CCO #SC01-001

Project: AS7.001.001 - Ogdensburg CSD CIP Phase 1
 1100 State Street
 Ogdensburg, New York 13669

**Change Order Authorization #SC01-001:
 CE #040 - Transportation Entrance Gate Changes**

5. CALL BOX MOUNT POLE DETAIL (PROVIDED BY DAY AUTOMATION)
NOT TO SCALE

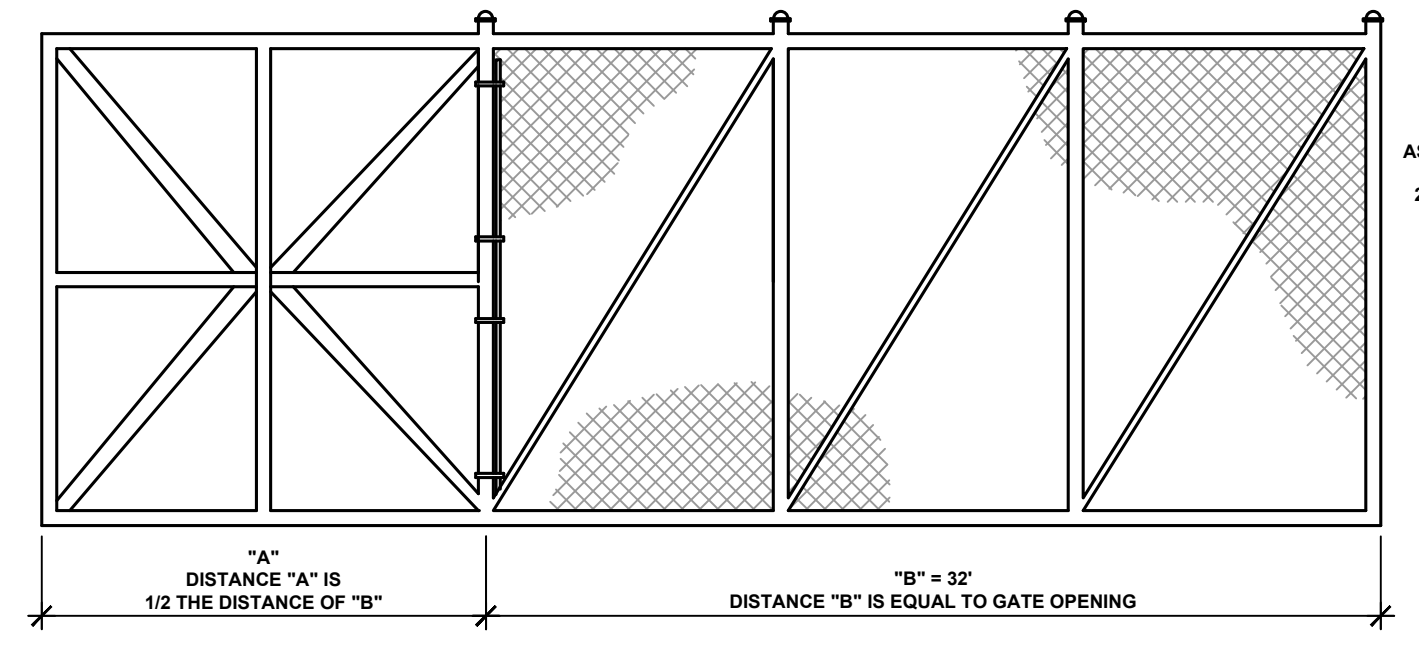
At the District's request, enhanced communication and security capabilities are being added at the entrance gate to the new Transportation Facility, per attached JC-14 drawings.	\$41,578.36
---	-------------

D.	Add for all labor, materials & equipment to provide enhanced security access control features to include exterior dual head camera & related pedestal, (2) Axis video intercoms w/ integrated card readers, fiber optic panel and access control panel for the drive entrance at the new Transportation Facility as per Contract Drawing(s) JC-14.

1 ELECTRICAL SITE PLAN
SCALE: 1" = 30'-0"

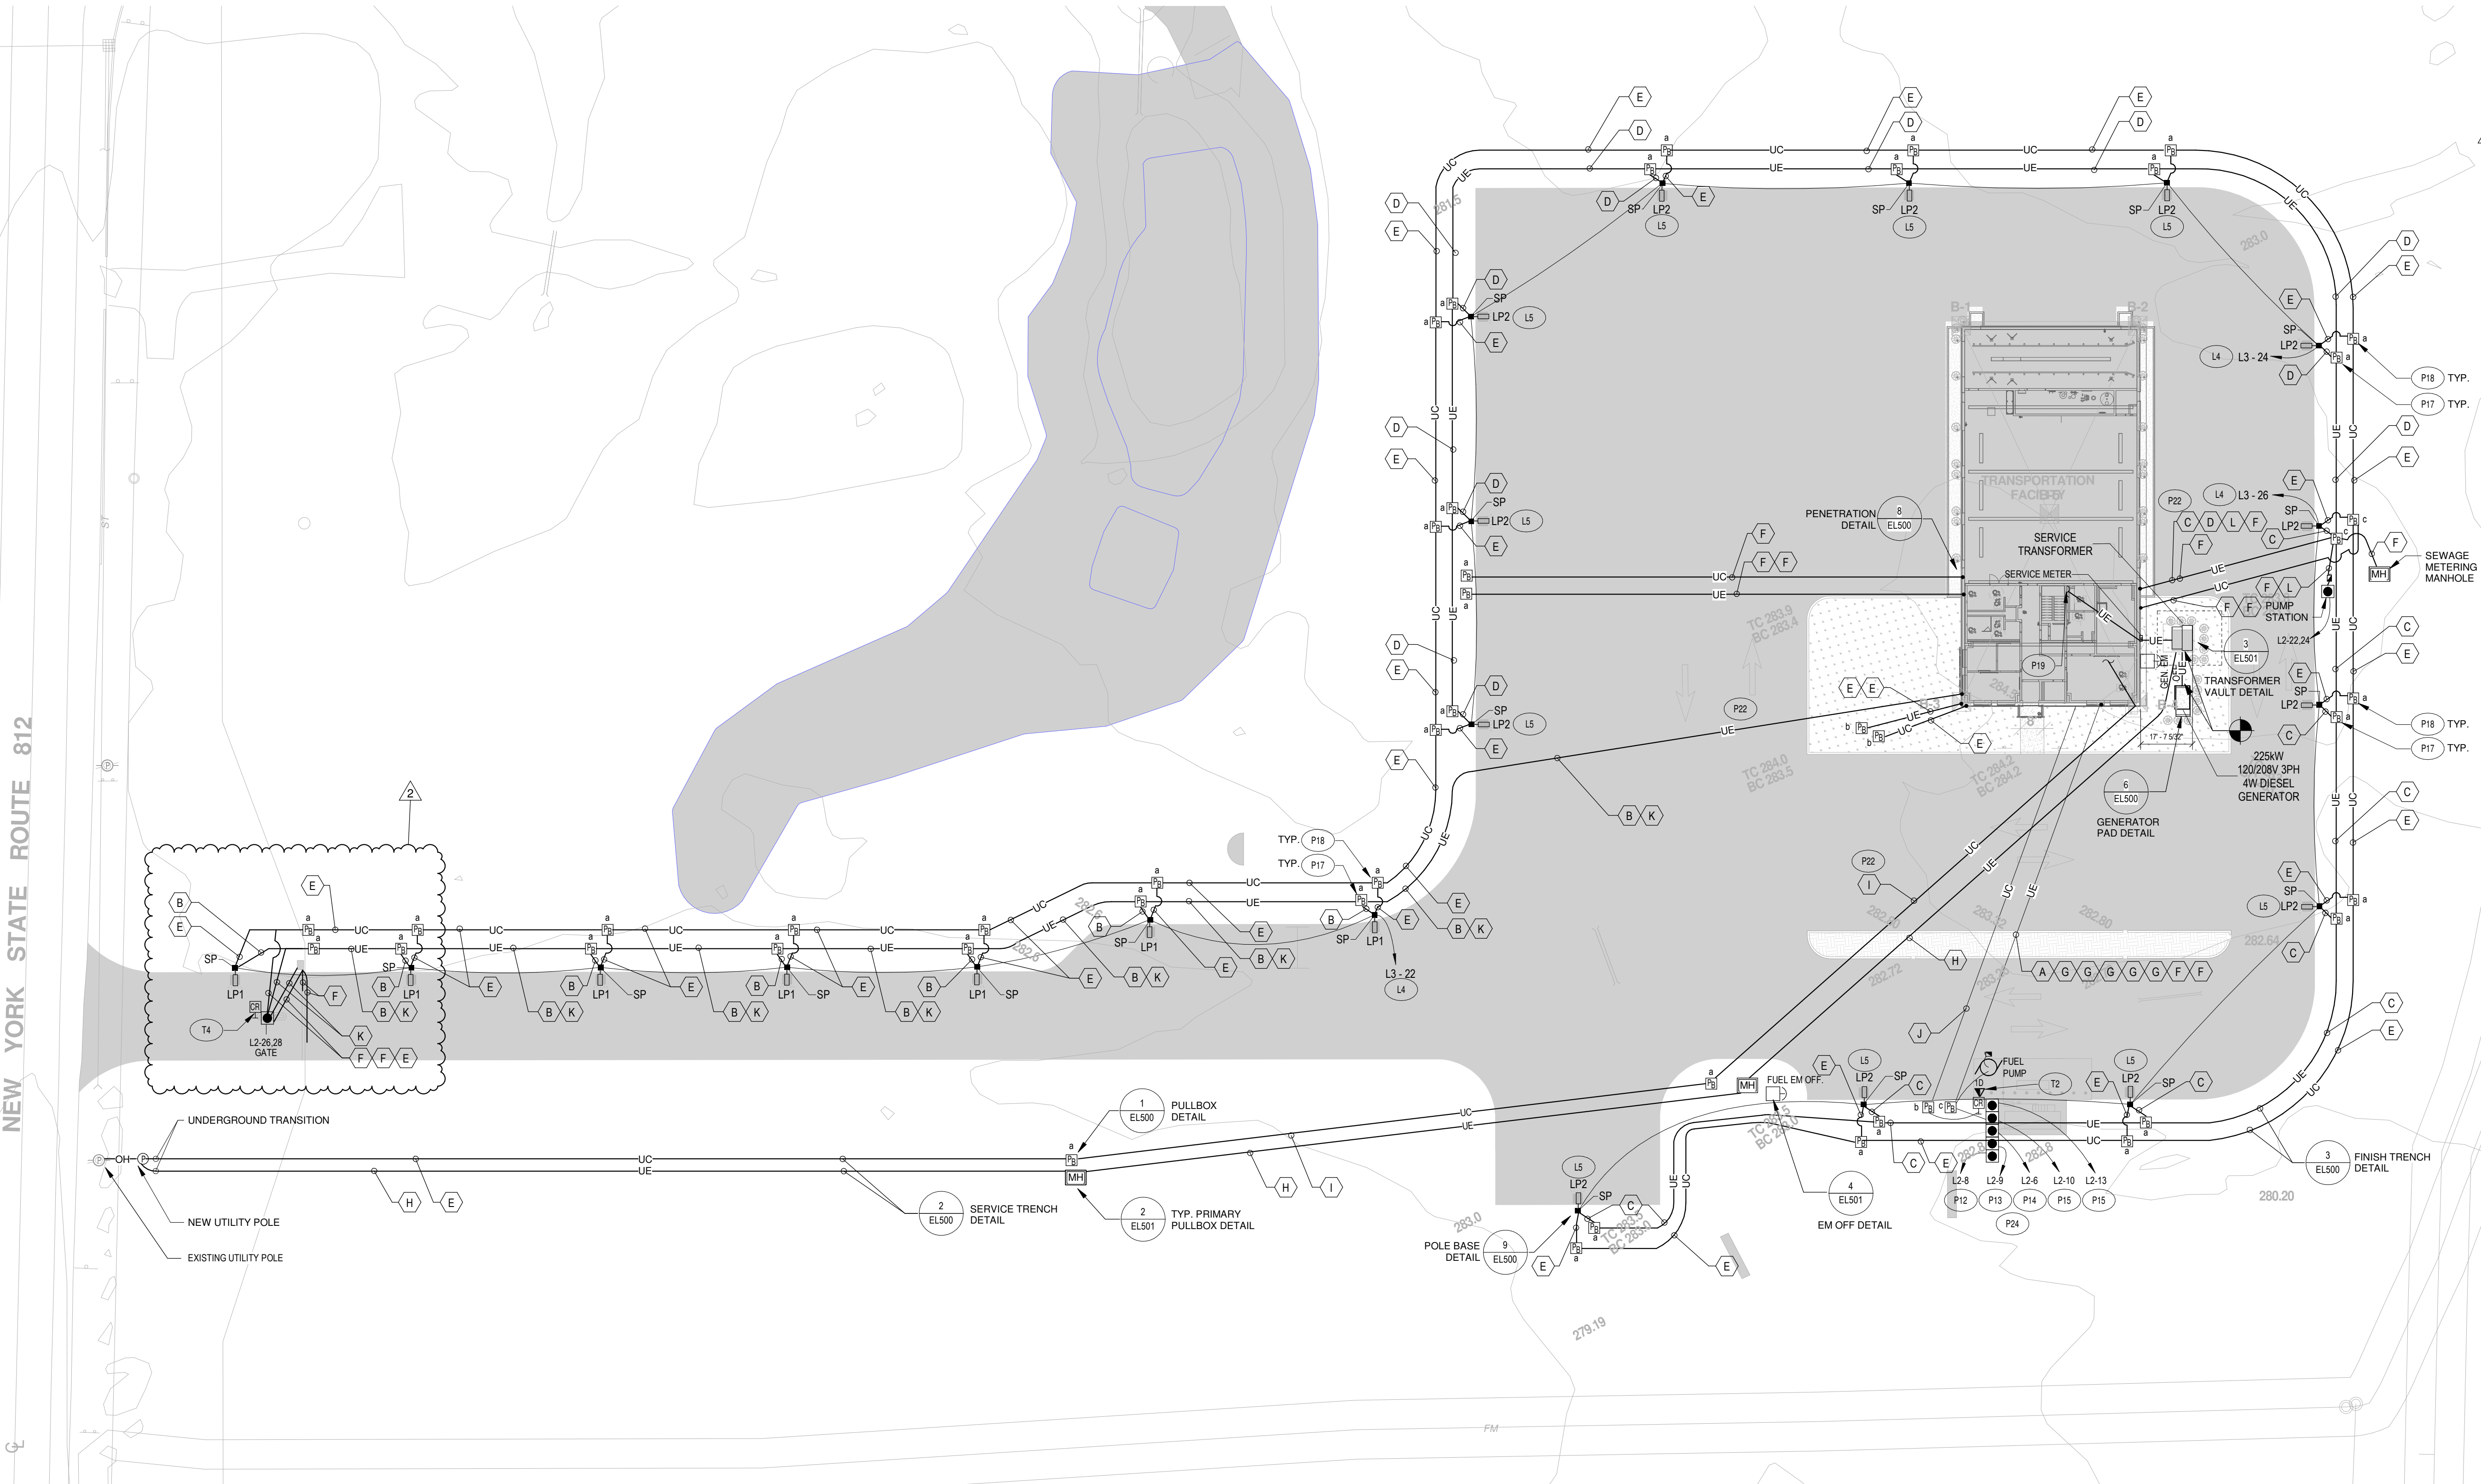
- PROVIDE (3) CATEGORY 6E UTP PLENUM RATED DATA DROP AND CONNECTIONS FROM LOCATION SHOWN TO (3) IN STORAGE RM 107. TYPICAL ALL DATA DROPS.
 - PROVIDE A CORNING PRODUCT NUMBER 0082P-31131-29 SINGLE MODE 6 STRAND (SS) PLENUM RATED INDOOR/OUTDOOR FIBER OPTIC CABLE FROM BUS GARAGE MDP TO NETWORK SWITCH PROVIDED BY DAY AUTOMATION. THEN PROVIDE CATEGORY 6E WIRING FROM NETWORK SWITCH TO CAMERAS AND CARD READER LOCATION. PROVIDE FIBER OPTIC PATCH PANELS ON BOTH ENDS AND TERMINATE ALL FIBER WITH LC CONNECTORS. ALL FIBER TO BE TESTED.
